PLAN REVIEW MATRIX – MID-PENINSULA HOUSING PROJECT SITE – CAPITOLA ROAD – SANTA CRUZ, CA

**Prepared at the request of:
The Mid Peninsula Housing Corporation
275 Main Street
Watsonville, CA 95076**

**Prepared by - Nigel Belton-Consulting Arborist
July 21, 2018**

SHEET NO.:
A100

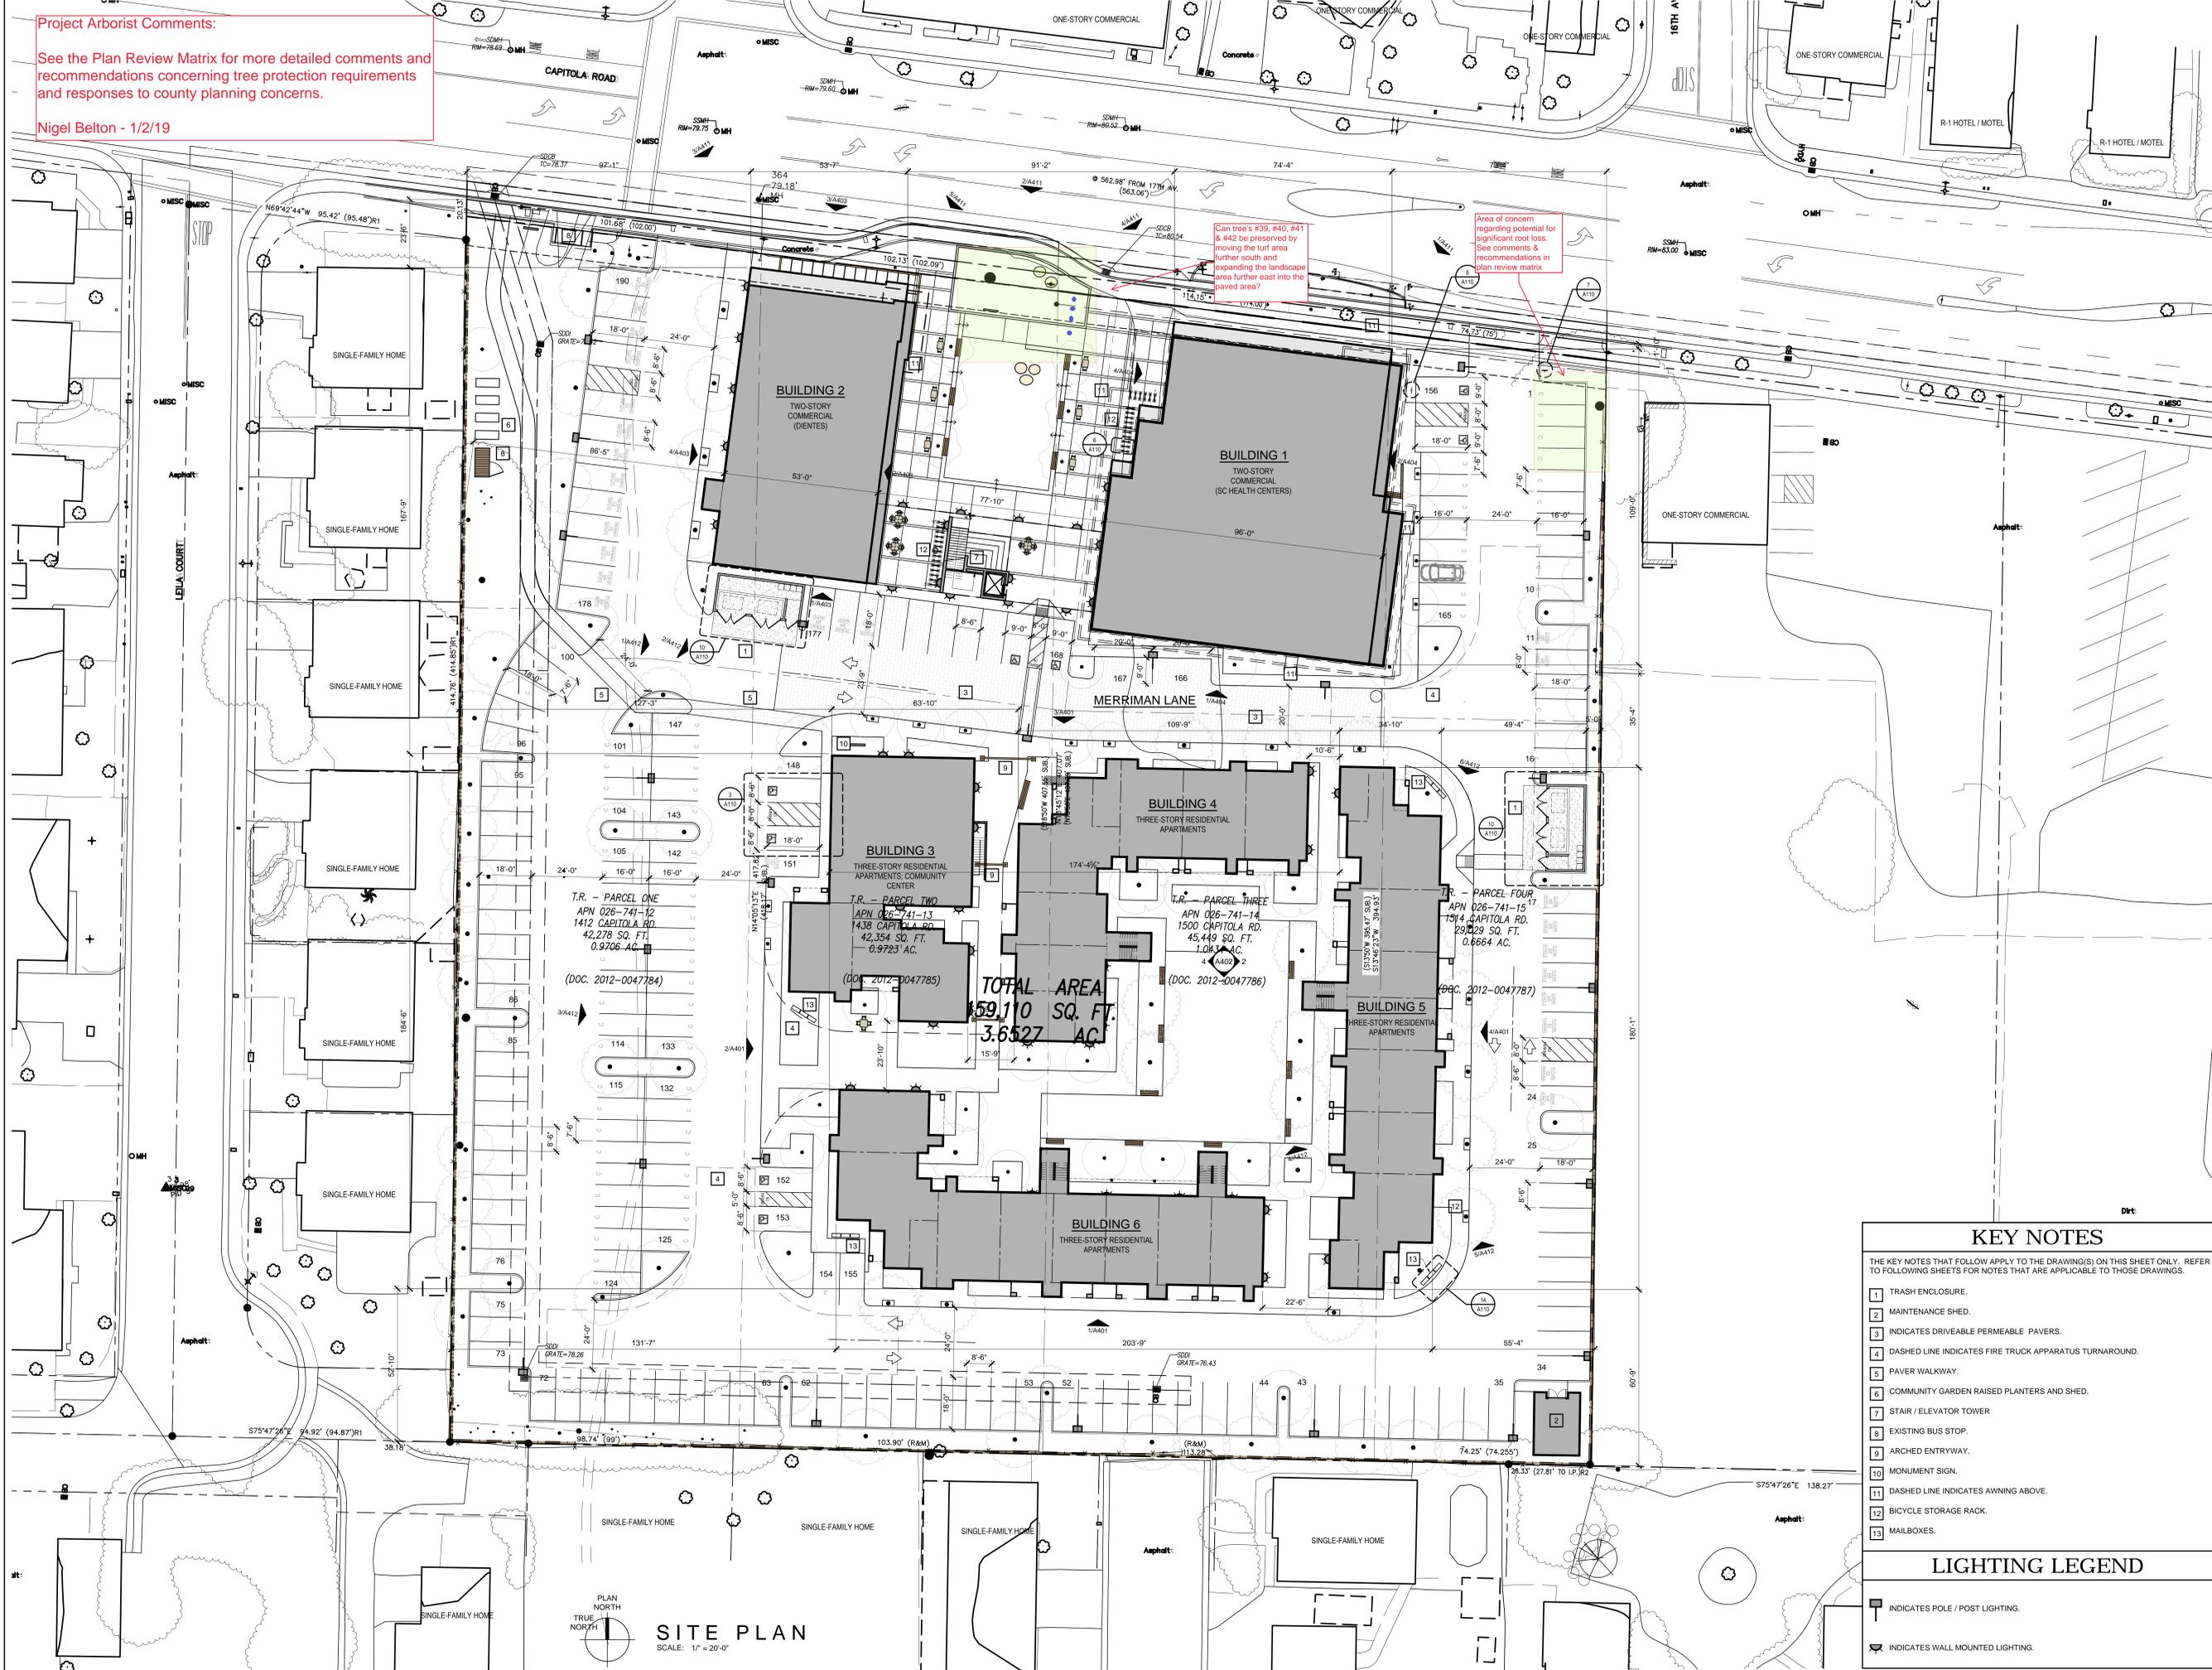
| # | SPECIES: | TRUNK DIAMETER AT 54-INCHES ABOVE NATURAL GRADE: | ESTIMATED HEIGHT: | ESTIMATED SPREAD: | HEALTH: (1 = Best Rating out of 5) | SUITABLE FOR PRESERVATION BASED ON CONDITION RATINGS: | REMOVE TREE BECAUSE OF LOCATION IN PROJECT AREA: | <u>PLAN REVIEW COMMENTS:</u> 1- RECOMMENDATIONS FOR TREE PROTECTION - PERTAINING TO THE REVIEW OF THE PRELIMINARY PLAN SET 2- PLAN REVIEW COMMENTS - PERTAINING TO THE SPECIFIC TREES IDENTIFIED FOR RE-EVALUATION BY THE COUNTY OF SANTA CRUZ |
|----|------------------|--|-------------------|-------------------|------------------------------------|---|--|---|
| 39 | Coast Live Oak | 15 | 30 | 20 | 3 | X | ? | <u>2- County review questions regarding tree preservation on the site:</u> - I recommend that consideration is given to expanding the landscape area around this tree and the adjacent oaks in order to preserve more root zone area, if at all possible (see the marked-up site plan). |
| 40 | Coast Live Oak | 9/9 | 30 | 15 | 3 | X | ? | <u>2- County review questions regarding tree preservation on the site:</u> - I recommend that consideration is given to expanding the landscape area around this tree and the adjacent oaks in order to preserve more root zone area, if at all possible (see the marked-up site plan). |
| 41 | Coast Live Oak | 12 | 30 | 25 | 2 | X | ? | <u>2- County review questions regarding tree preservation on the site:</u> - I recommend that consideration is given to expanding the landscape area around this tree and the adjacent oaks in order to preserve more root zone area, if at all possible (see the marked-up site plan). |
